| TITLE: TH MI Links clone | | REV: 1.1 |
| | Company: Sourcery Studios MIAW | Sheet: 1/1 |

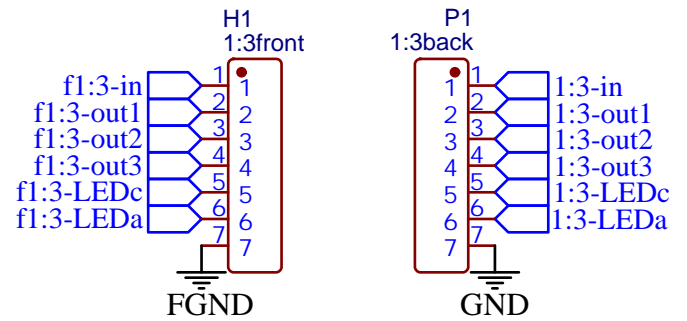
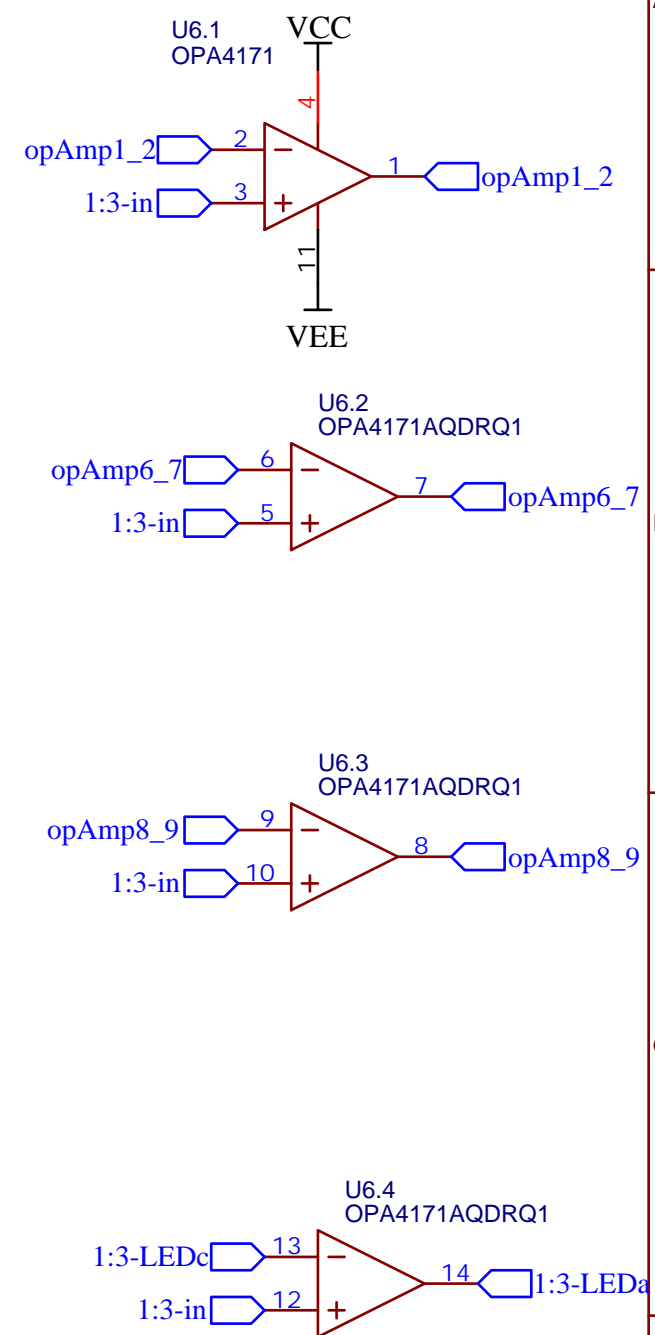
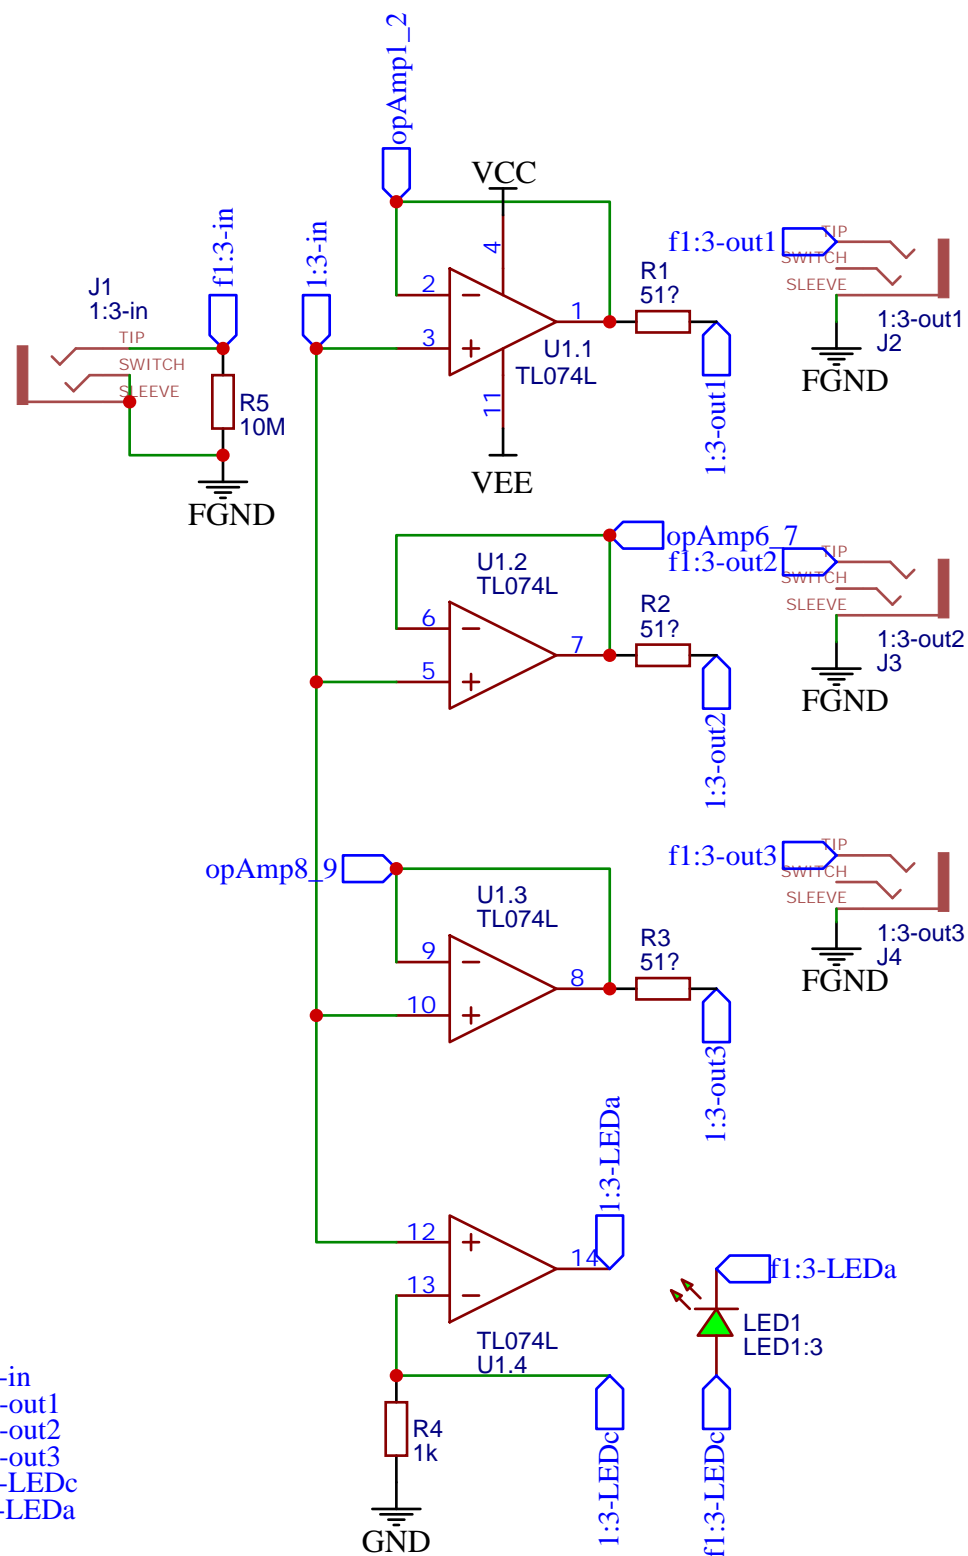
Rev 1.2 Added original schematics and checked all connections. fixed one value.
Rev 1.3 Added the gnd I miees, and fixed the caps.
Rev 1.4 R5 missing on PCB fixed, LED1&2 a/c switched on other f-board. Power connector turned!!!
removed unneccessary nets
Rev 1.4 Fixed the double silkscreen on back of front panel, also fixed cap sizes 100nF

| TITLE: Sheet_3 | | REV: 1.0 |

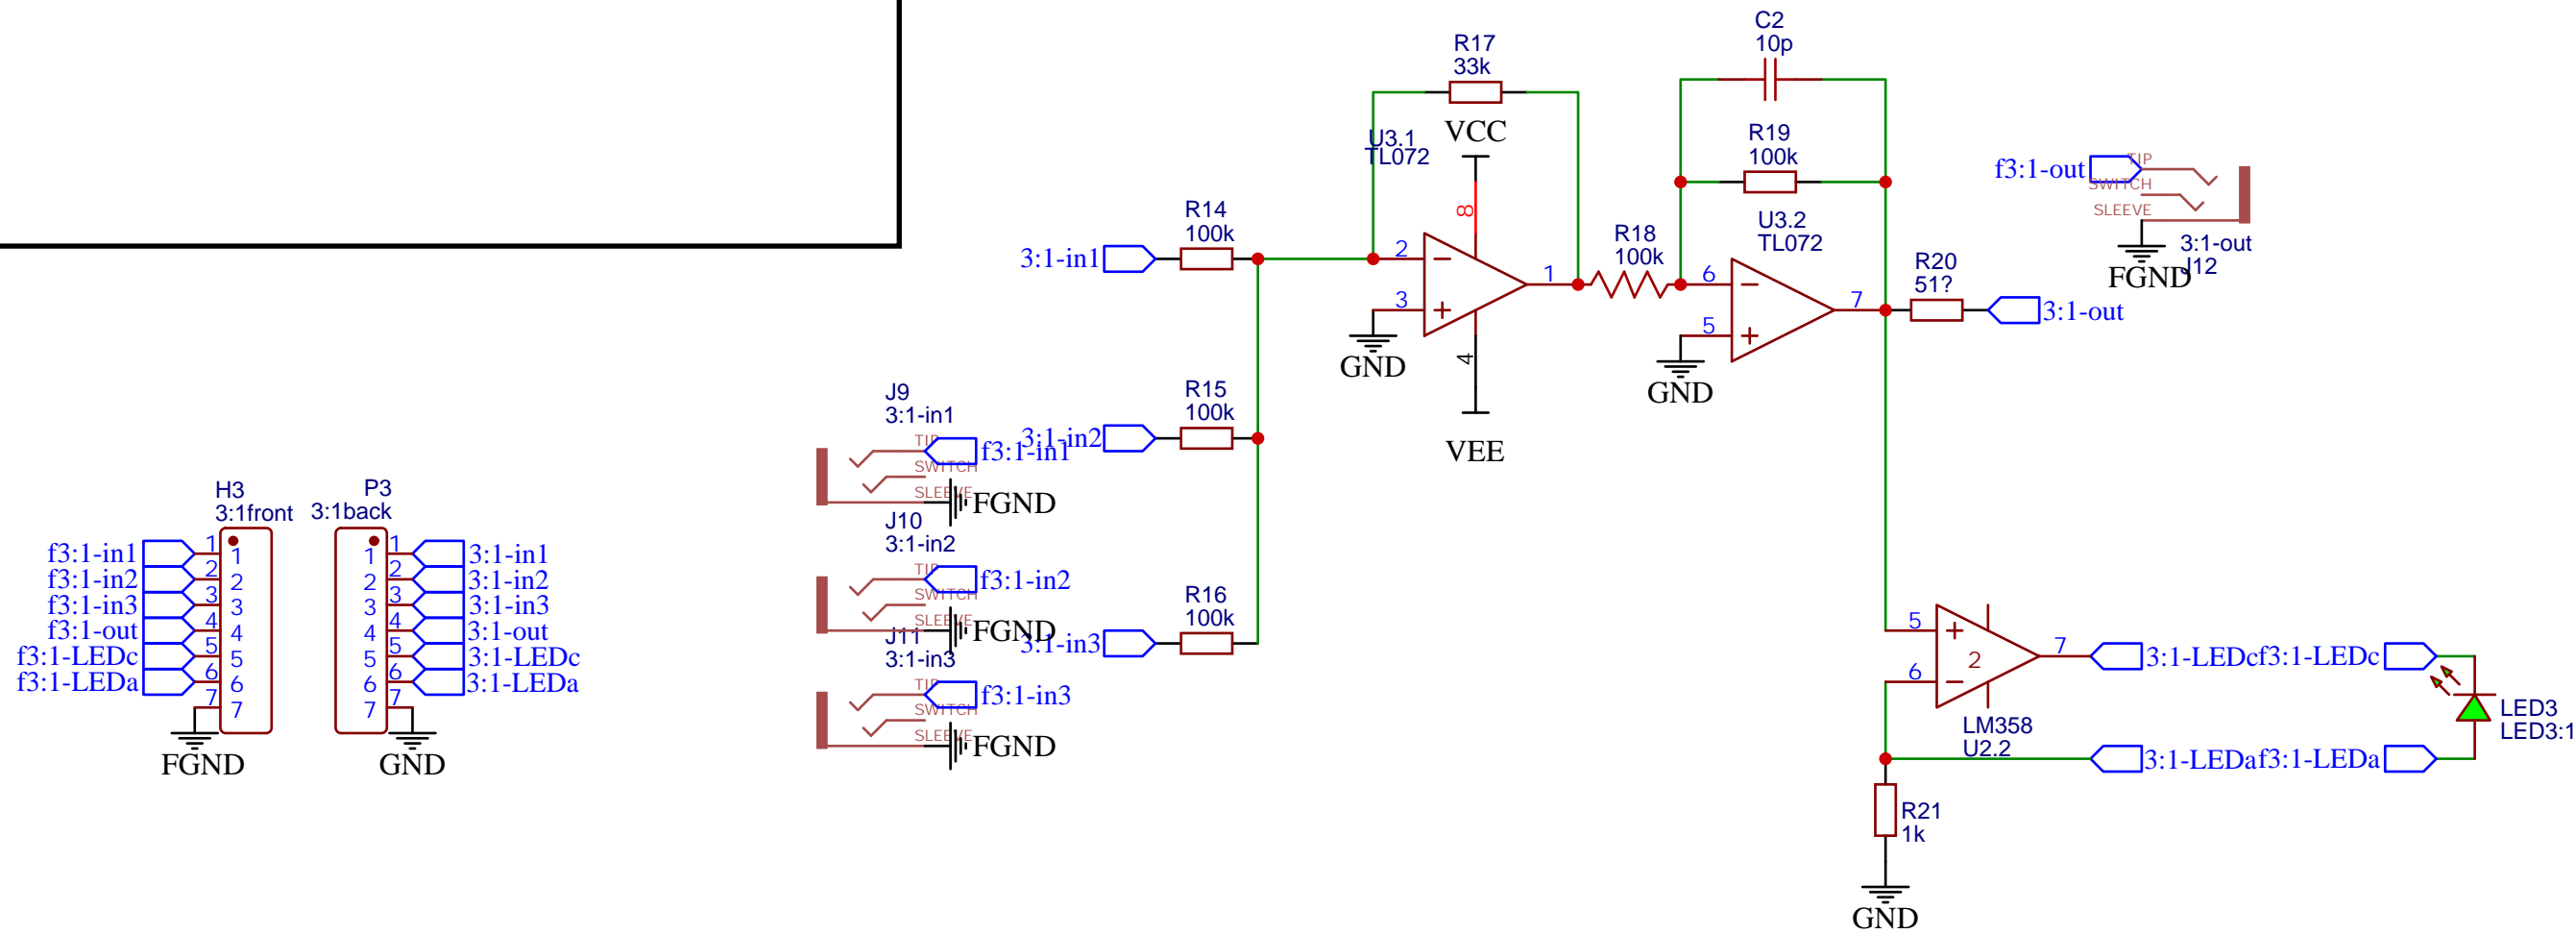
Fixes:
R15/R17 wrong value -> 33k
Fixed U4.2 to U3.2
